TECHNICAL BULLETIN
Bell Helicopter **TEXTRON**

No. 212-06-204

MODEL AFFECTED: 212

SUBJECT: VERTICAL FIN COVER HINGE PIN IMPROVED
INSTALLATION

Figure 1
New Hinge Pin Installation

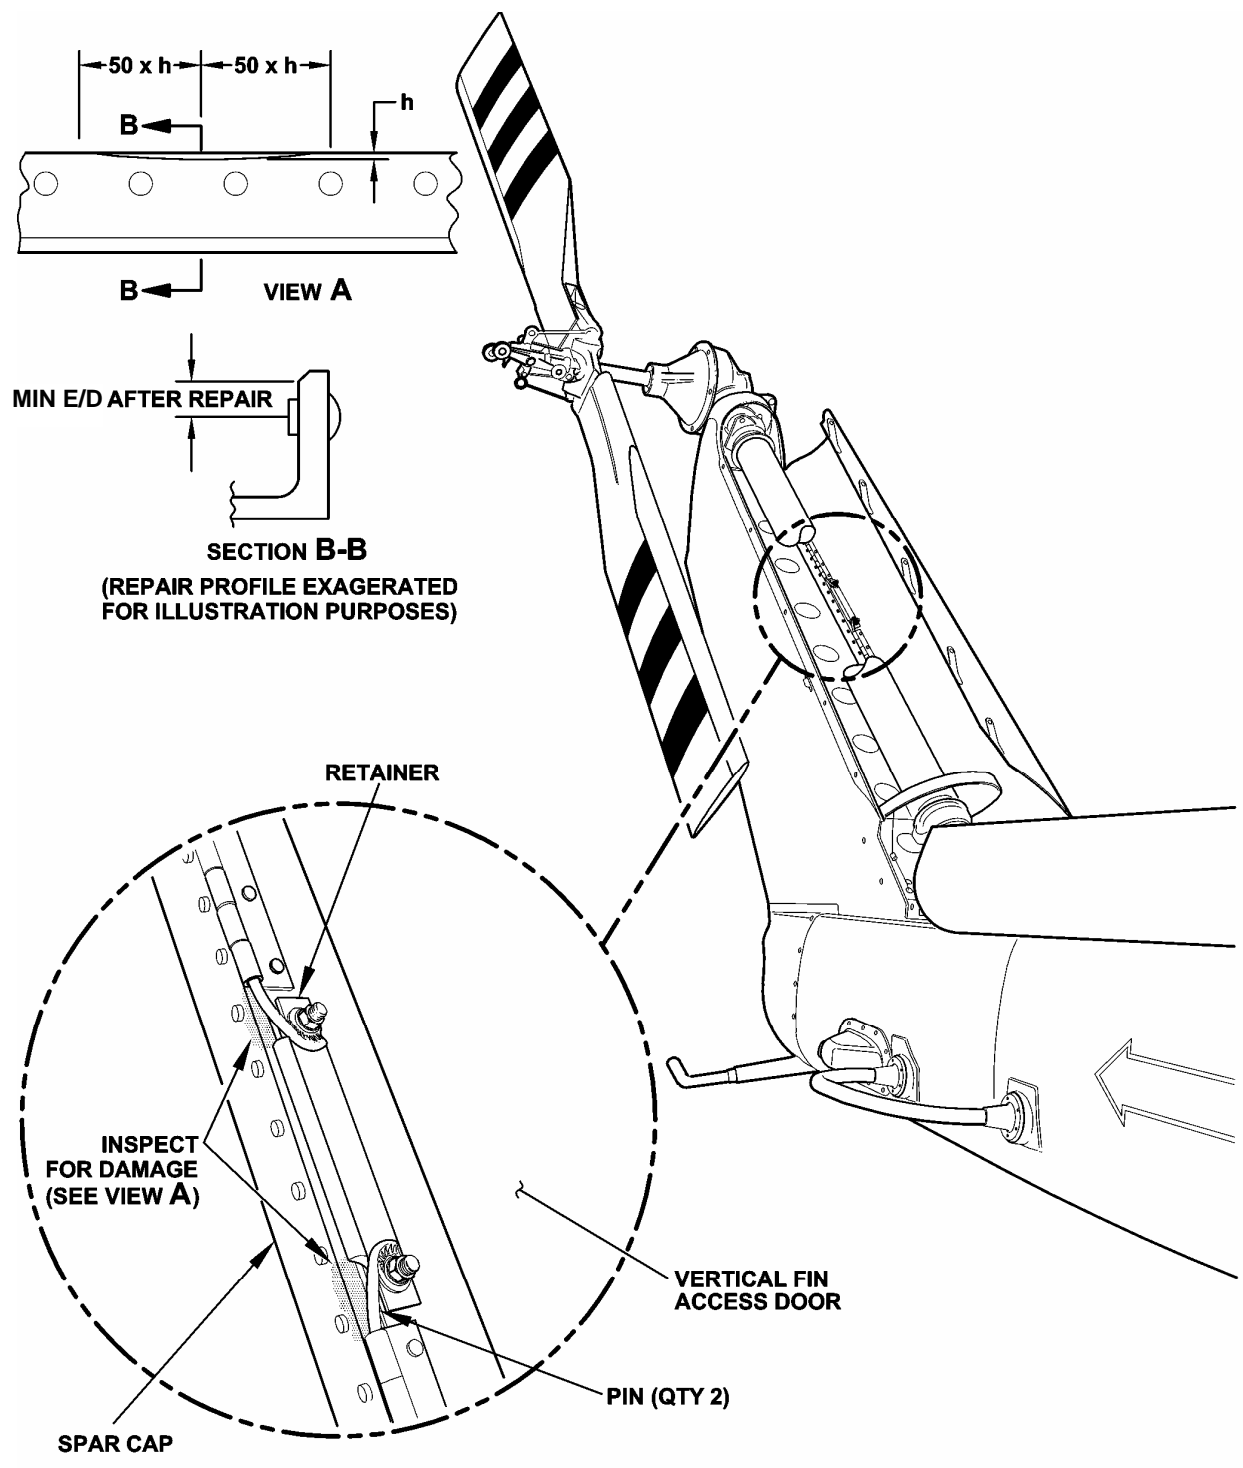
Bell Helicopter has designed a new installation for the vertical fin cover to prevent chaffing damage to the left hand spar cap caused by improperly bent hinge pins. This technical bulletin allows retrofit of the installation on earlier aircraft.

4. Remove door by removing hinge pins. Remove cotter pins at each end of the fixed half of hinge and discard.
5. Inspect spar cap as indicated in Figure 1, View A, for any chafing damage caused by improperly installed hinge pins.

- a. Chafing damage of 0.040 inch-deep or less (up to the full width of the flange) may be blended to a length-to-depth ratio of 50:1 (in each direction from the deepest point) and refinished, provided the distance between the center of the nearest rivet and the repaired area is at least 1.5 time the rivet diameter (min E/D). Remove minimum amount of material and polish repair area using 400-grit sandpaper. Removal of the hinge from the fin may be required.

- c. Report any damage in excess of 0.040 inch-deep to Product Support Engineering.

6. Reinstall door by inserting Pins P/N 209-031-816-119. Attach pins to door using existing screws, 209-031-816-123 Retainer and MS21042L3 Nuts, as shown on Figure 1. Close door.
7. Make an entry in helicopter historical records indicating compliance with this technical bulletin.
8. Make helicopter safe for flight.
